| Project Title: | Palmdale Hybrid Power Project - Compliance |
| Document Title: | Palmdale Energy, LLC's Petition for Amendment |

PALMDALE ENERGY PROJECT

**Subject: PALMDALE ENERGY, LLC'S PETITION FOR AMENDMENT
PALMDALE HYBRID POWER PROJECT
DOCKET NO. (08-AFC-9C)**

FIGURE 3-1b SINGLE-LINE DIAGRAM, POWER BLOCK

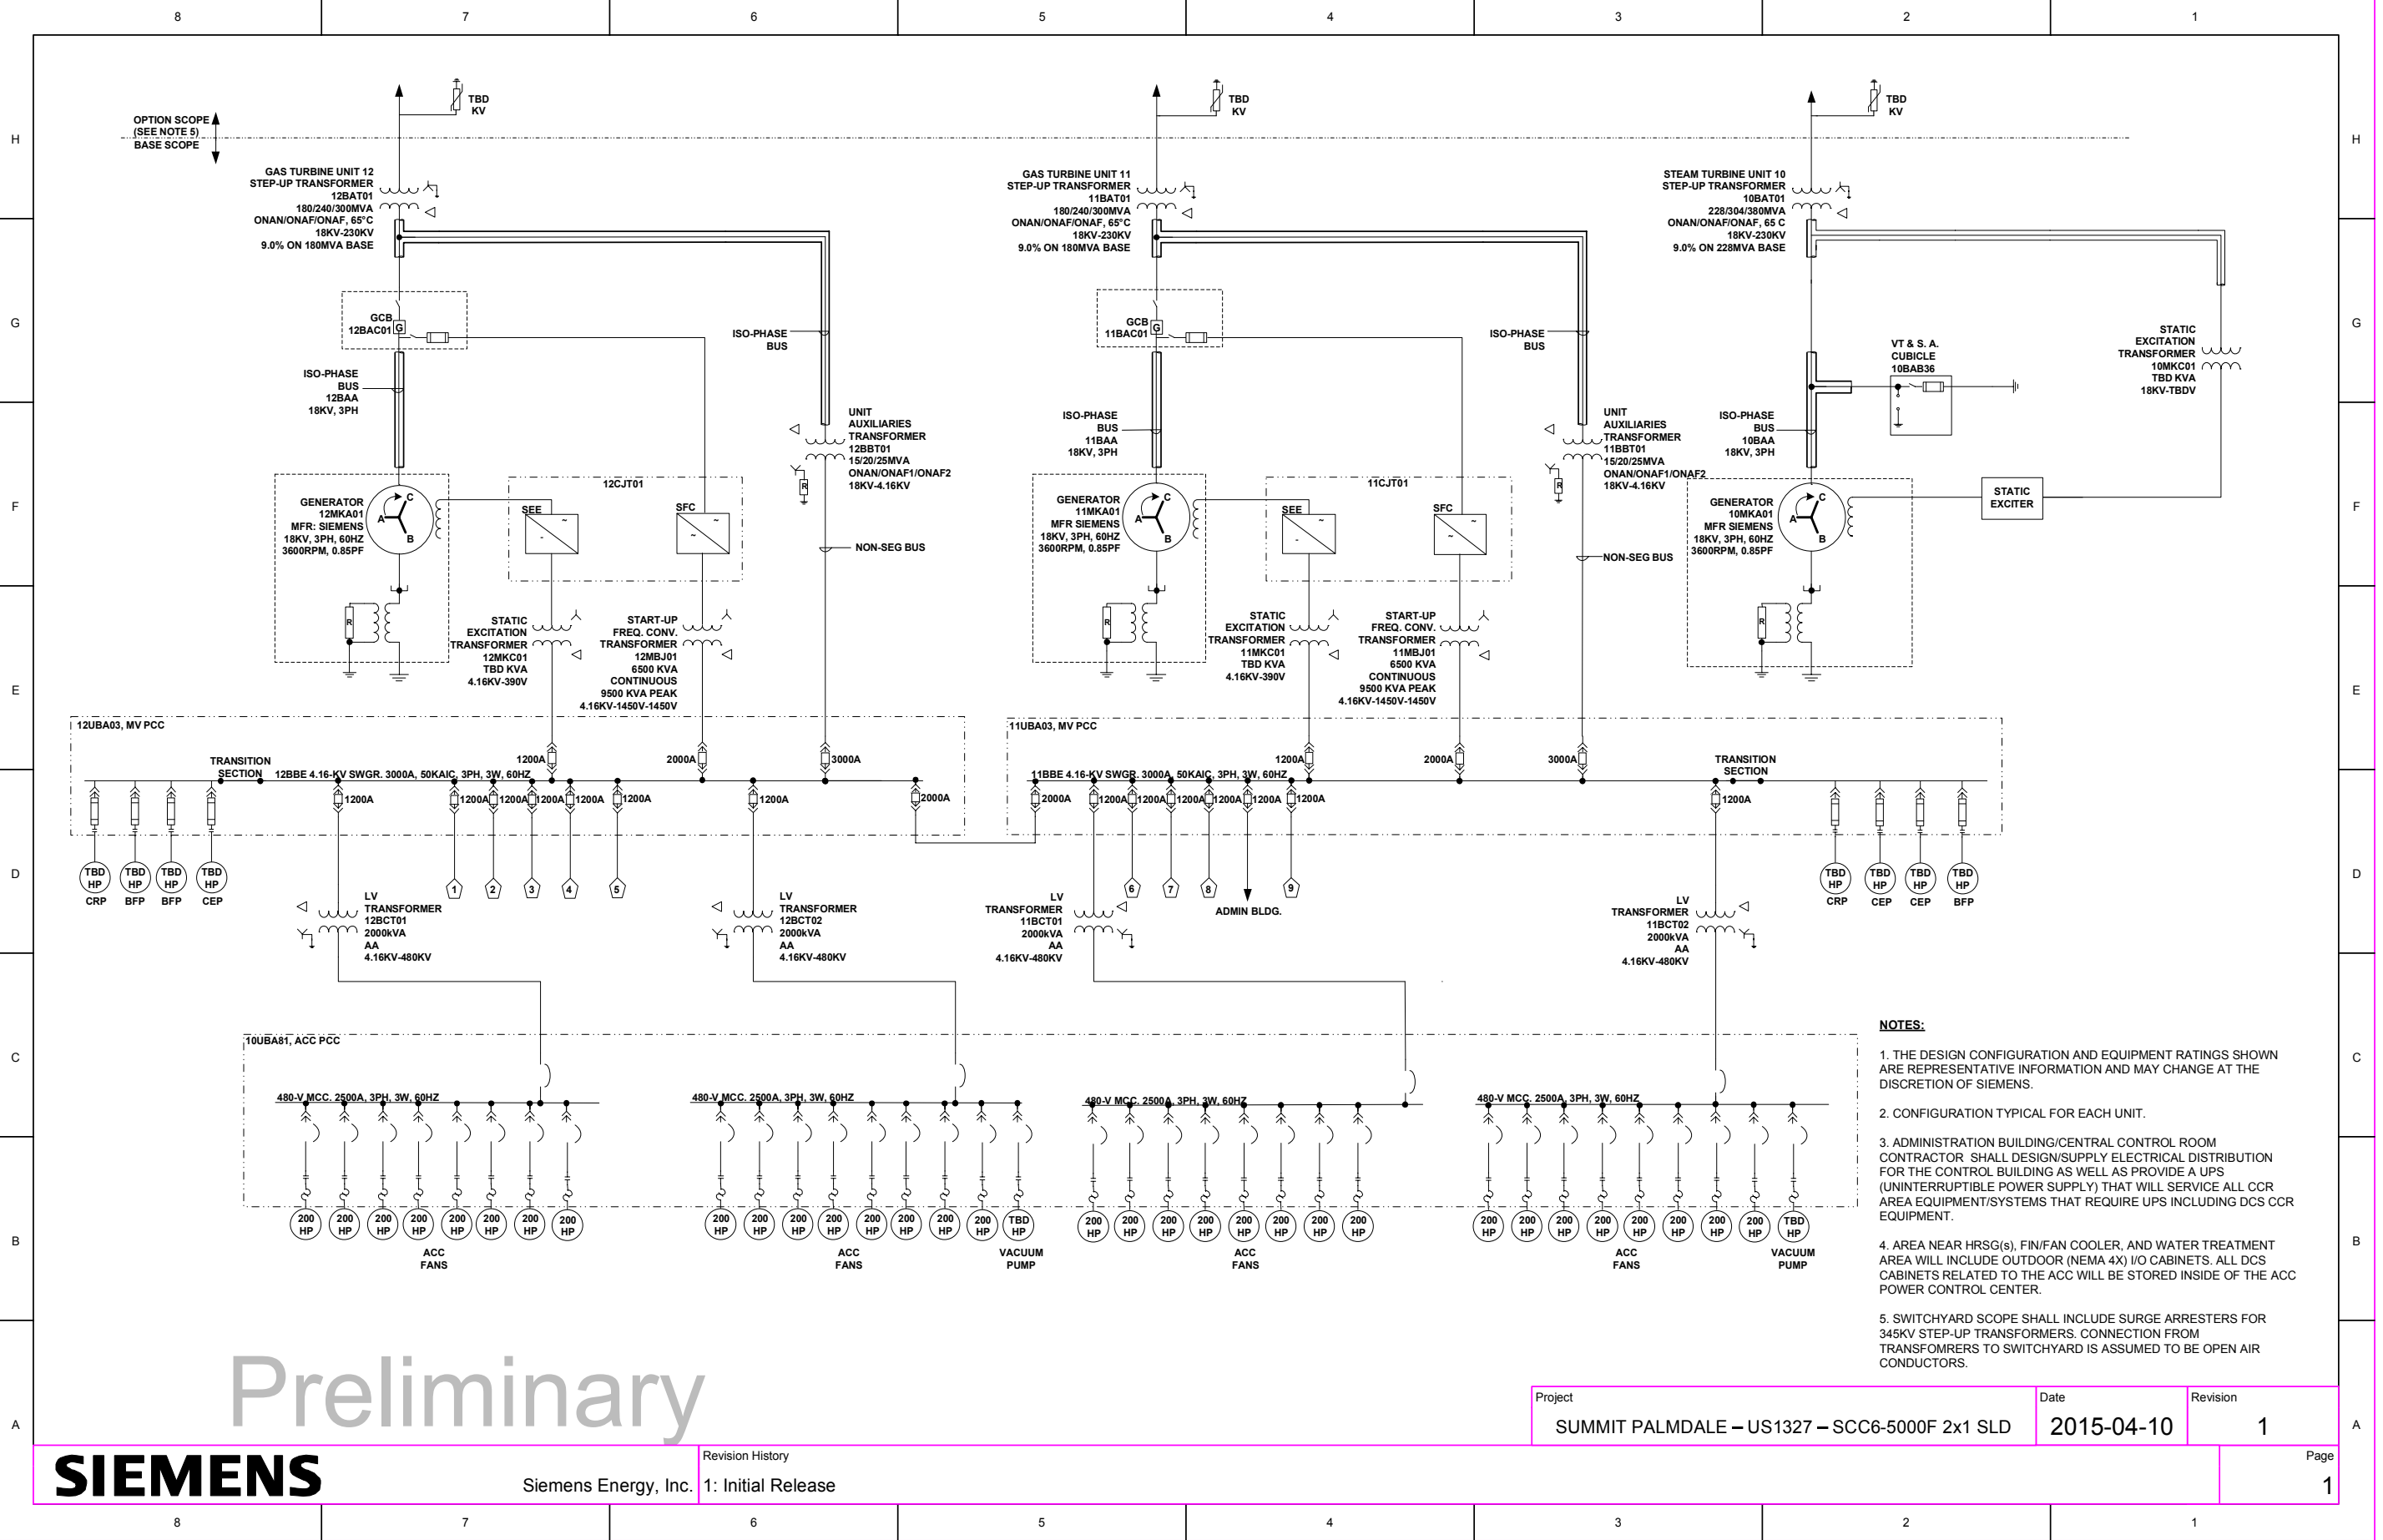
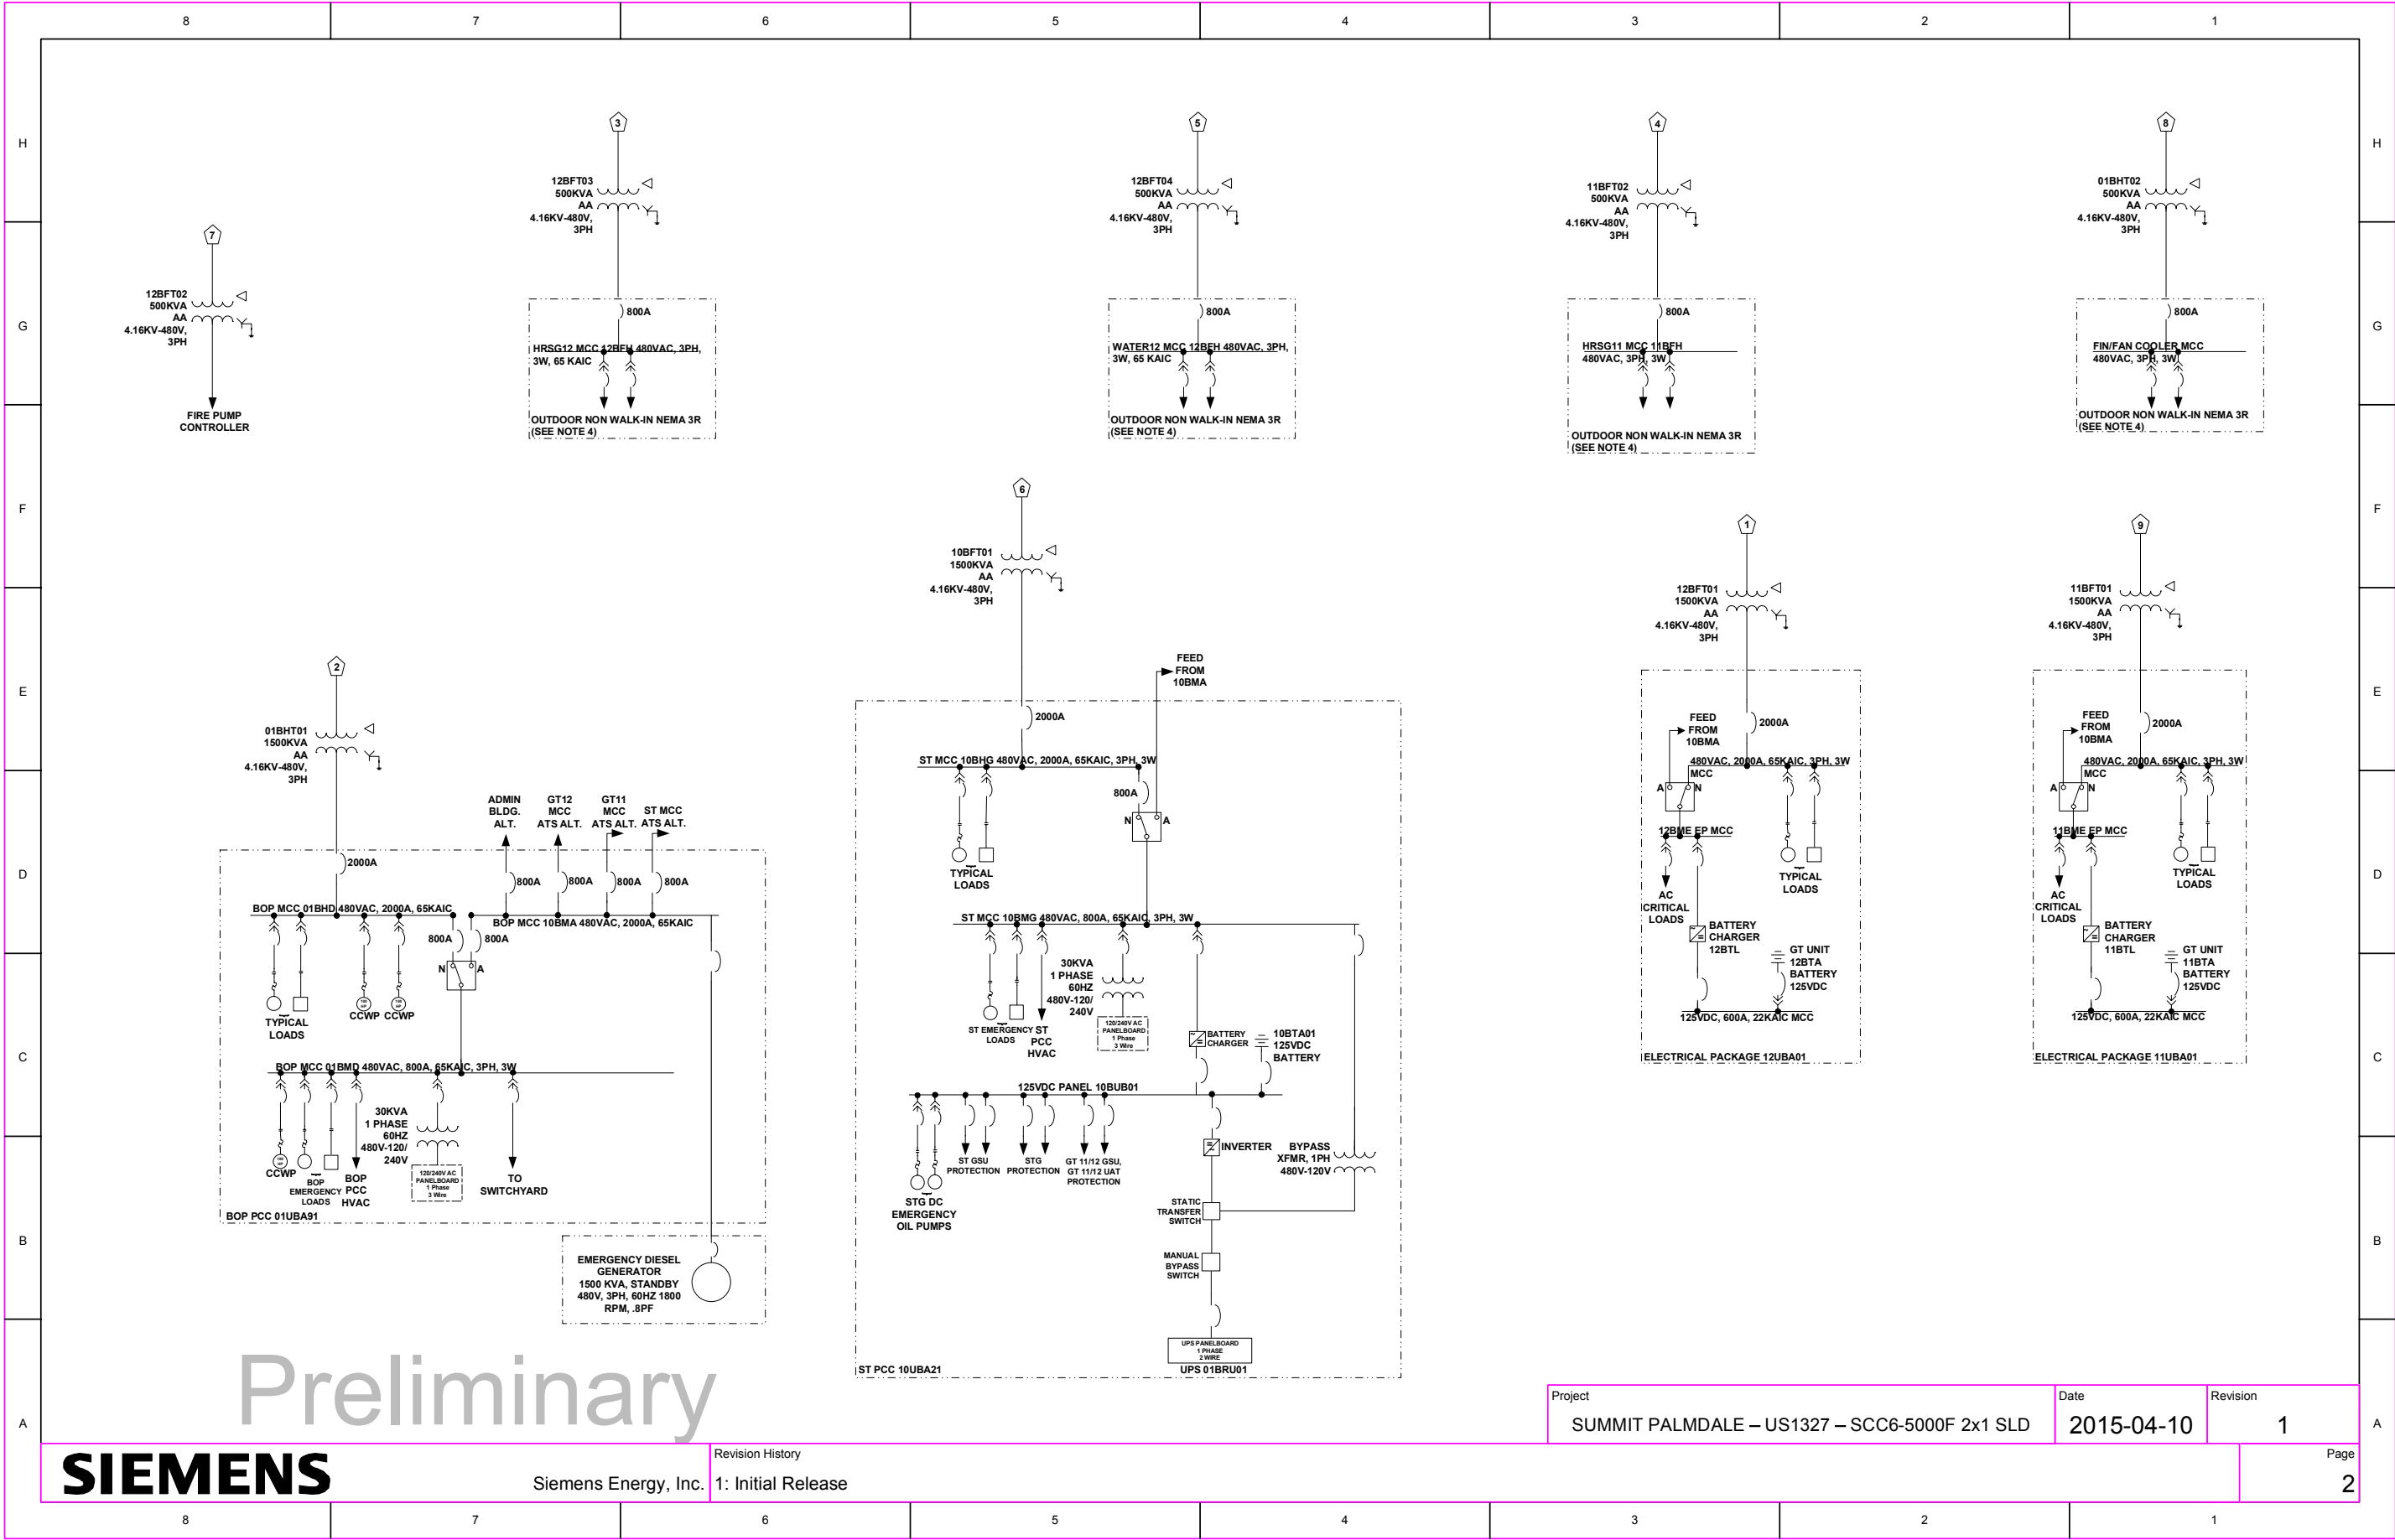
Since the Modified Project is replacing the generation equipment, new preliminary single line diagrams are provided at this end of Section 3 of this Petition. Figure 3.1a shows the single-line diagram for the new project switchyard and Figure 3.1b shows a single-line diagram for the power block.
